**PLANNING & ZONING COMMISSION MEETING  
CITY OF LEANDER, TEXAS  
Pat Bryson Municipal Hall ~ 201 North Brushy Street  
Leander, Texas**

**Thursday ~ June 23, 2016 at 7:00 pm**

ZONING CASE 15-TOD-Z-030  
 CONCEPT PLAN 15-TOD-CP-006

## TYLERVILLE COMMERCIAL PUD & CONCEPT PLAN

**EXHIBIT C**  
**CONCEPTUAL SITE LAYOUT**  
**AND LAND USE PLAN**  
**TYLERVILLE COMMERCIAL**  
 LEANDER, TEXAS

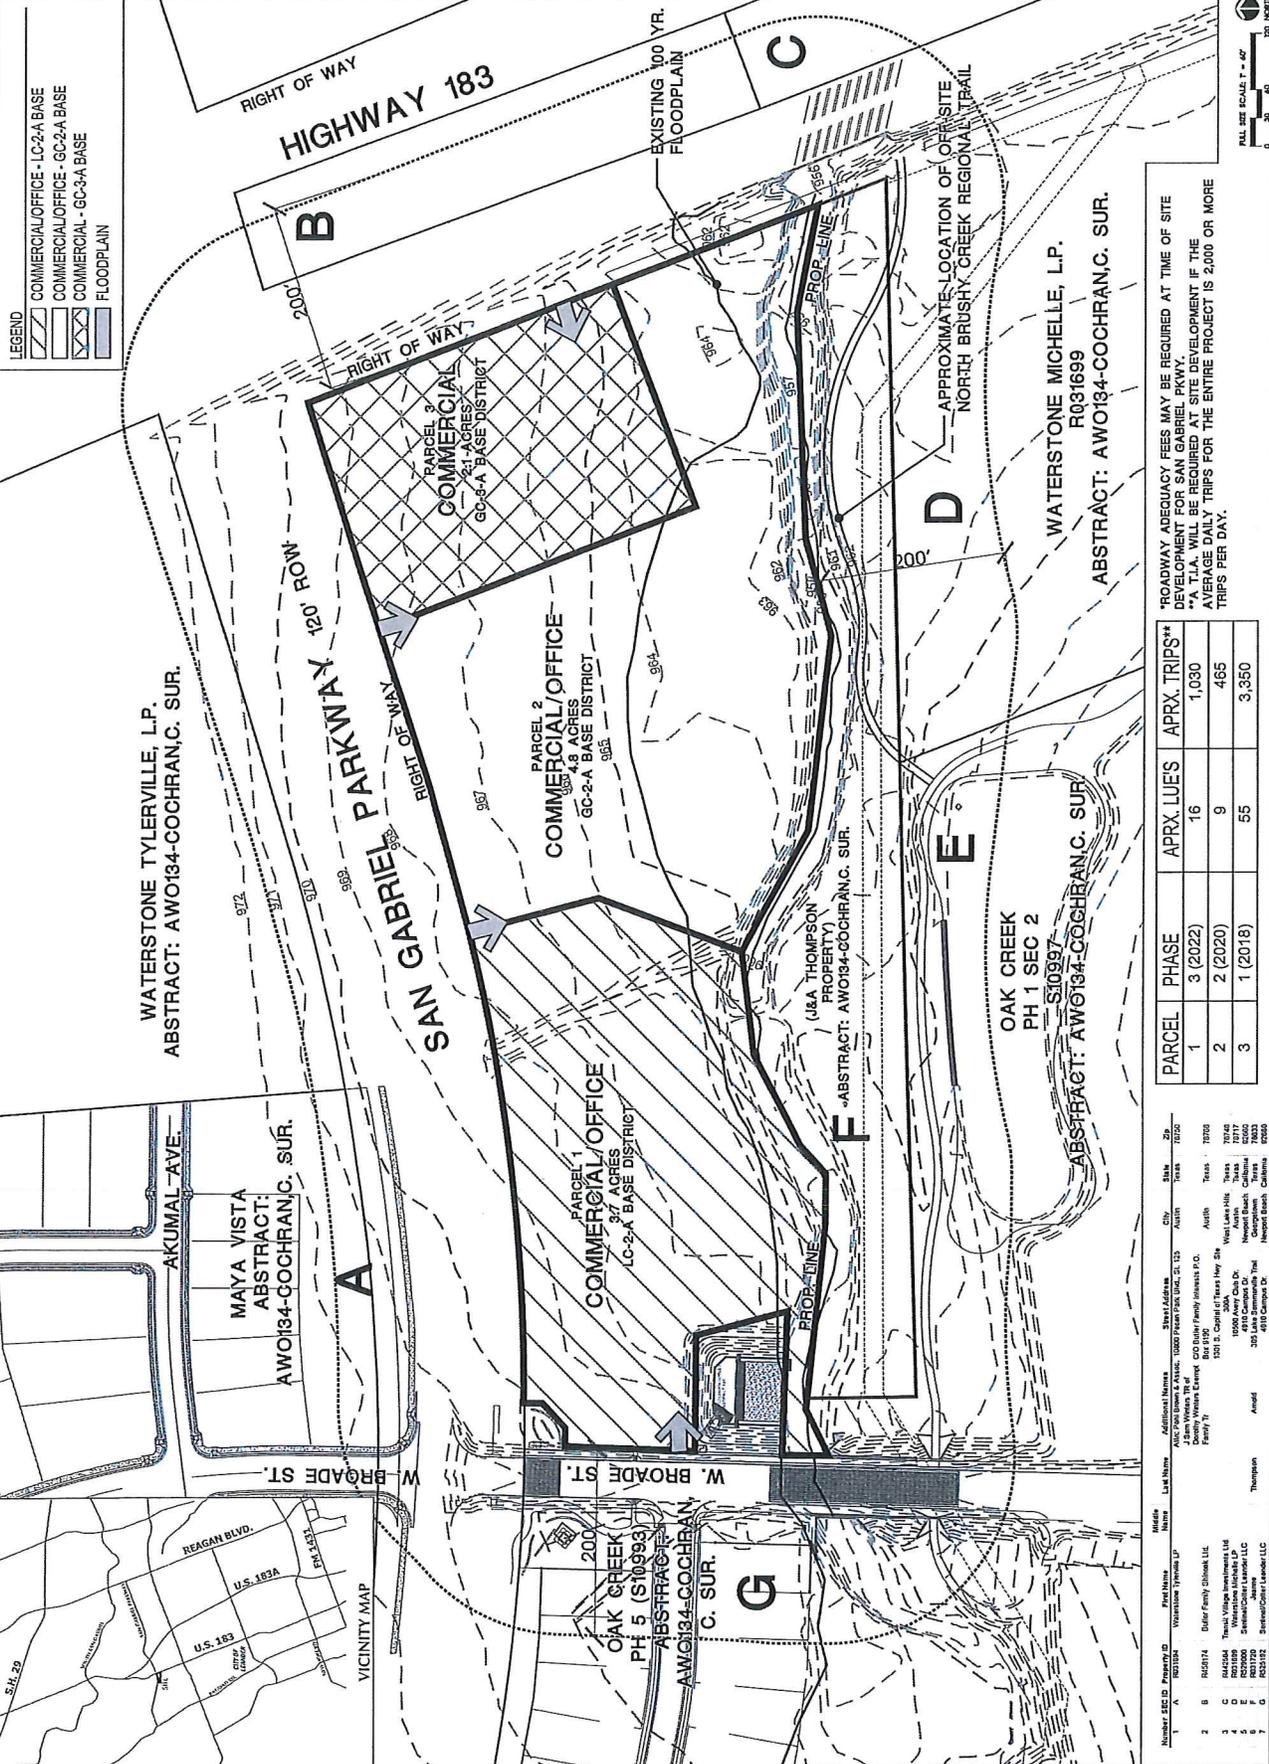
2. Add a requirement that the continuous building frontage will not be required for Parcel 2 as long as the buildings are oriented towards the creek corridor instead of San Gabriel Pkwy. The creek shall be treated as the street with regard to the masonry requirements. The creek shall include an active edge with a trail system, pedestrian amenities, outdoor seating, landscaping, etc.

3. Add a note to Exhibit E stating that the site plan is conceptual and has not been reviewed by City Staff. A formal review will be conducted at the site development stage of the process.

**EXHIBIT E**

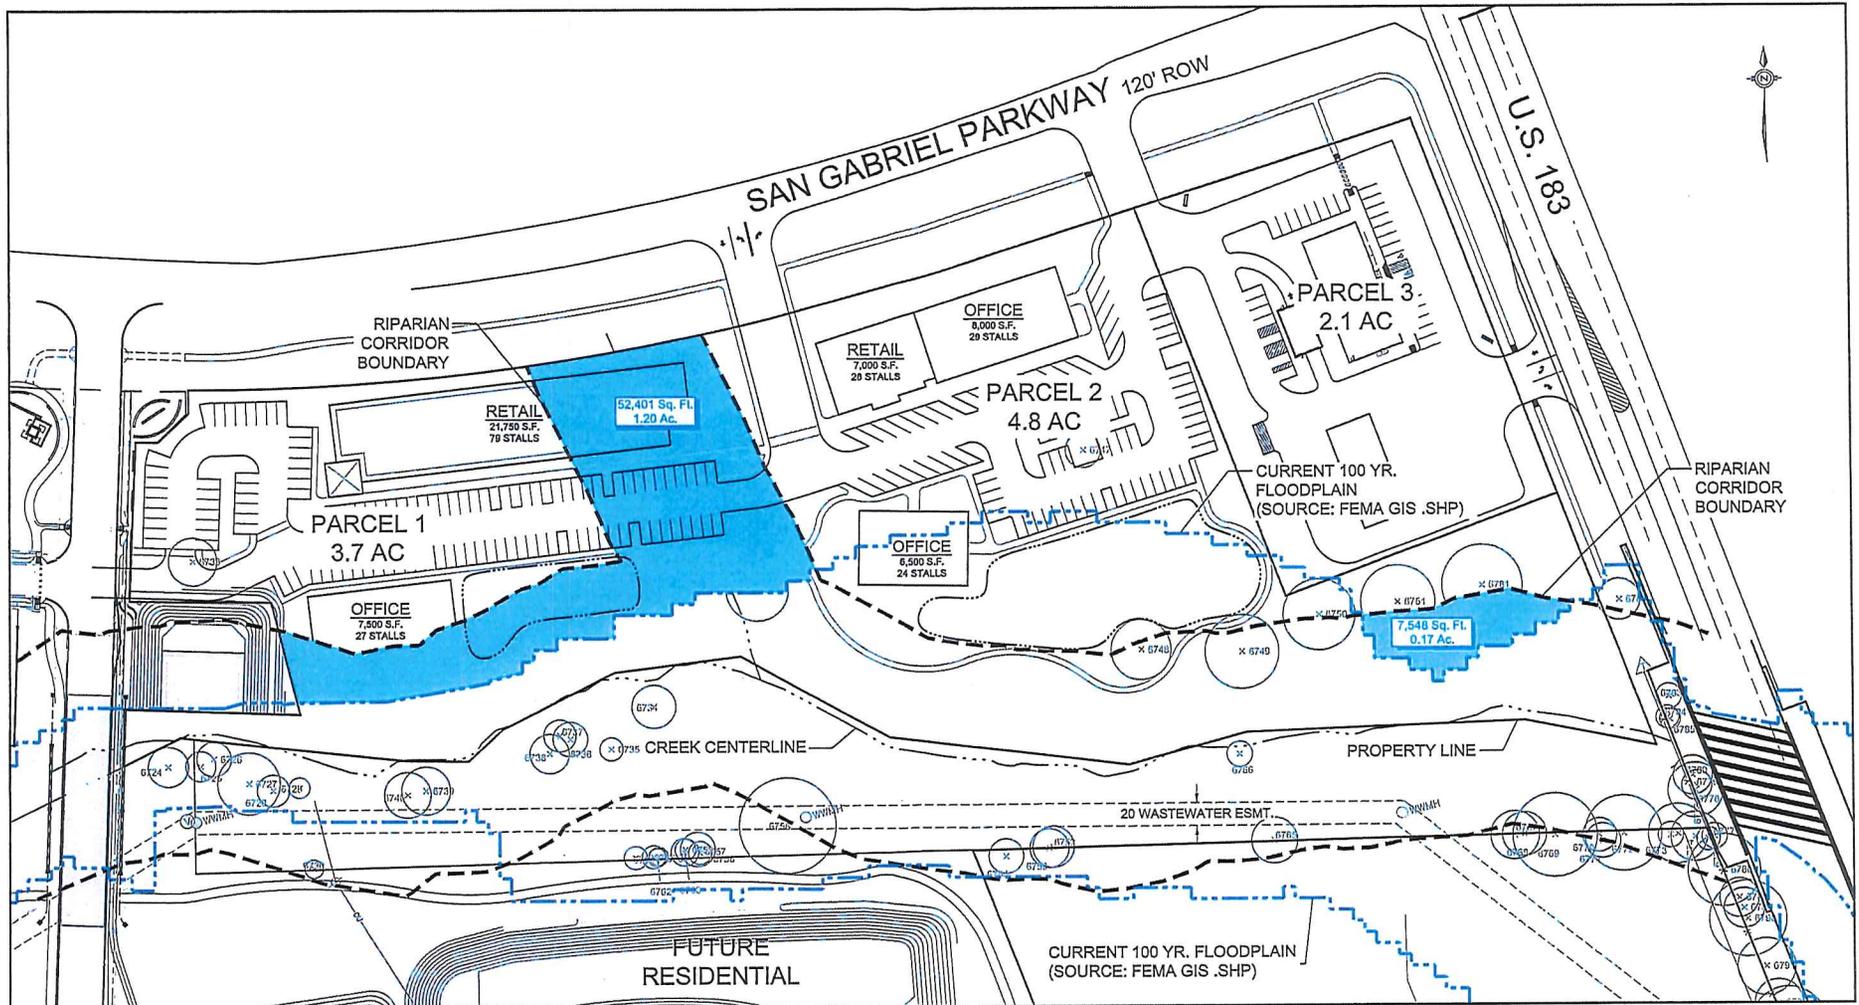
1. Update the PUD to meet the intent of the ordinance with regard to continuous building frontage along US 183. An example could include relocating the pumps to allow for another building between US 183 and the pumps.
